BID BULLETIN NO. 2
For LBP-HOBAC-ITB-GS-20181211-01

PROJECT : One (1) Lot Supply, Installation, Testing and Commissioning of Supervised Sprinkler System at LANDBANK UPLB Office Building

DATE : January 31, 2019

1 FIRE SUPPRESSION LAYOUT AT GROUND FLOOR

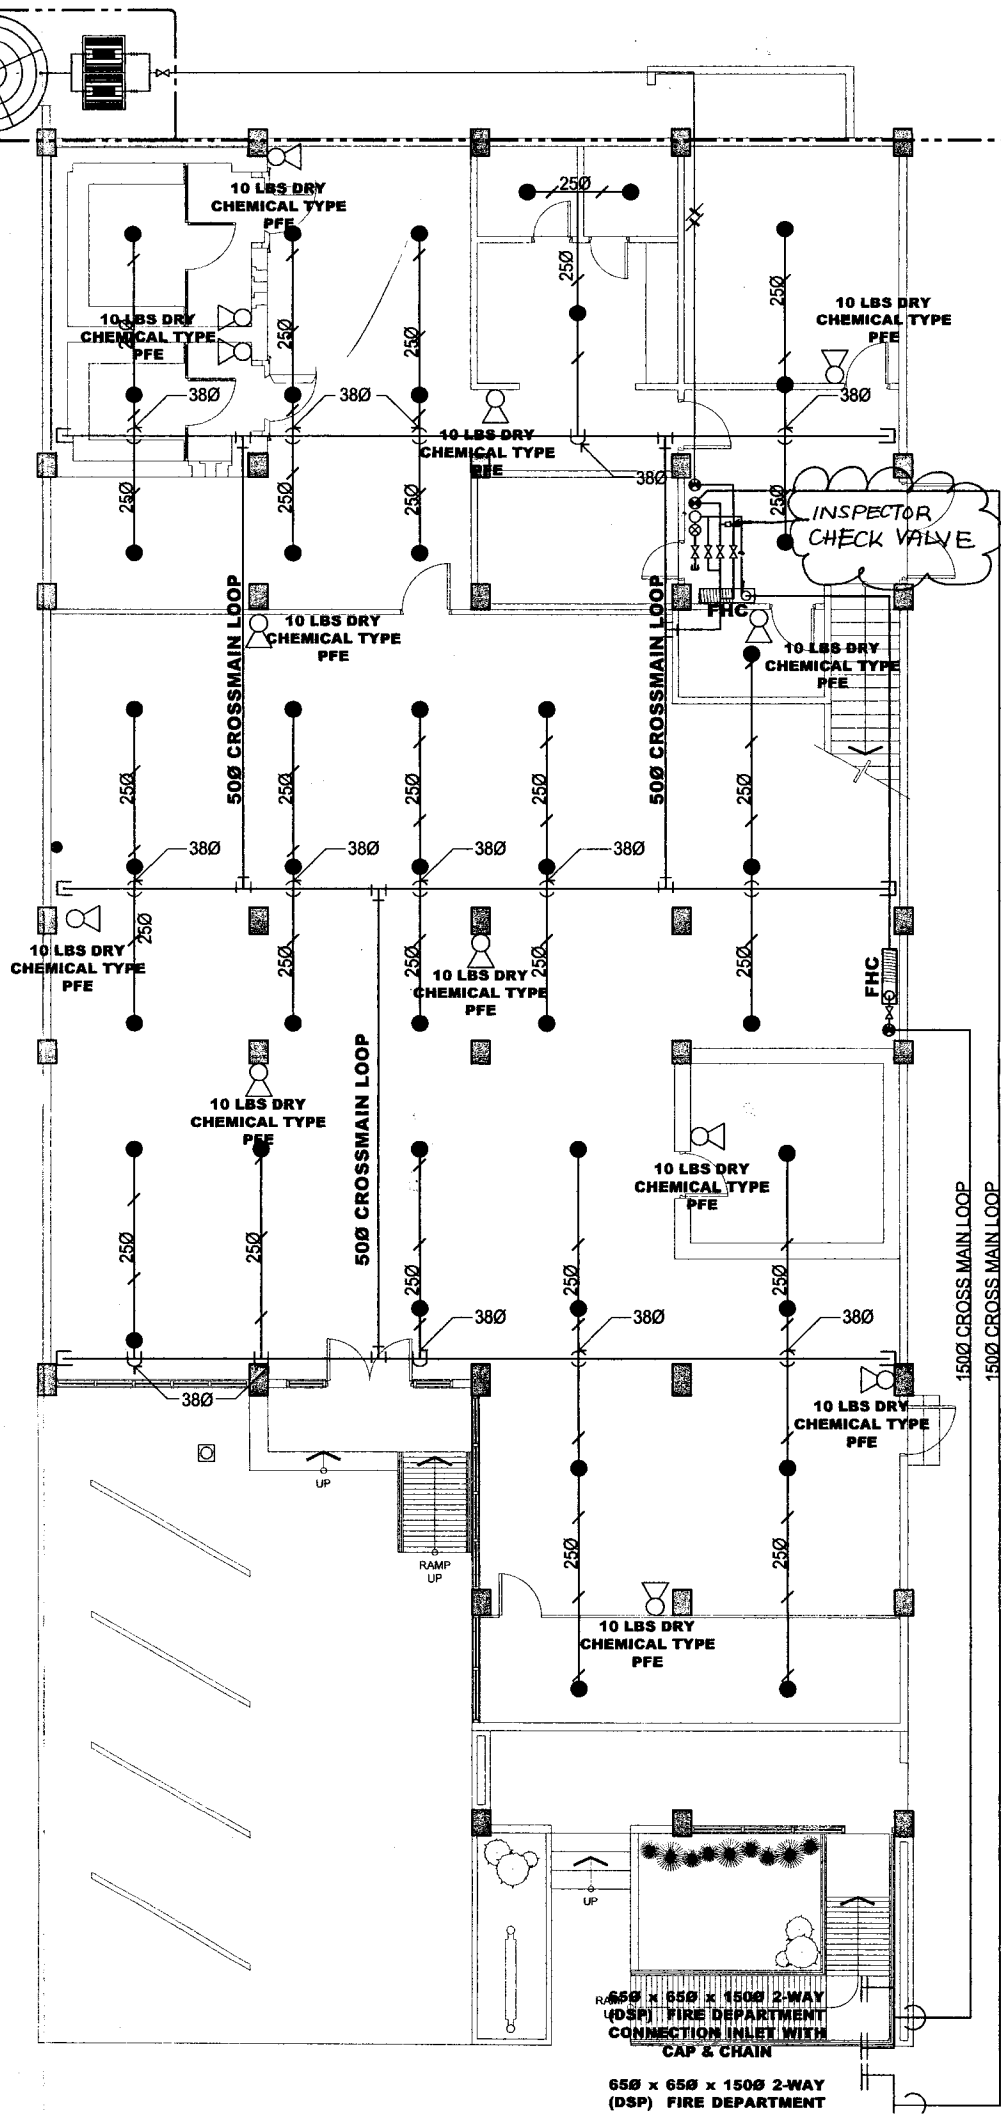
BIDDER'S QUERY	LANDBANK'S RESPONSE
1) As shown on the plans, is it the intent to install two (2) 150 mm diam. Dry Standpipe Risers?	There are two (2) Dry Standpipe Risers, one (1) is connected to Fire Hose Cabinet and the other one is directly connected to the Sprinkler System.
2) There is no pump schedule shown on the plans. Do bidders have to do the hydraulic calculations for pump size and rating?	220 V, 3-phase, 60 Hz Capacity, 300 GPM at 8 Bar with jockey pump, controller Direct-on-Line and standard Accessories Excel Series, Standard Approved or any approved equal that can satisfy and is most suitable for the project is acceptable.
3) Do bidders need to correct the plans to comply with the Fire Code and NFPA Standards?	There is no need to correct the plans. Any deviations during the implementation shall be reflected on the As-Built Plans.

PROPOSED WATER TANK FOR SPRINKLER SYSTEM (LOCATION SUBJECT FOR APPROVAL), BESTANK CODE 20000 OR APPROVED EQUAL, CAPACITY: 5000 GALLONS WITH 1 UNIT 2.50 HP BOOSTER PUMP AND 1 UNIT 7.50 HP FIRE PUMP
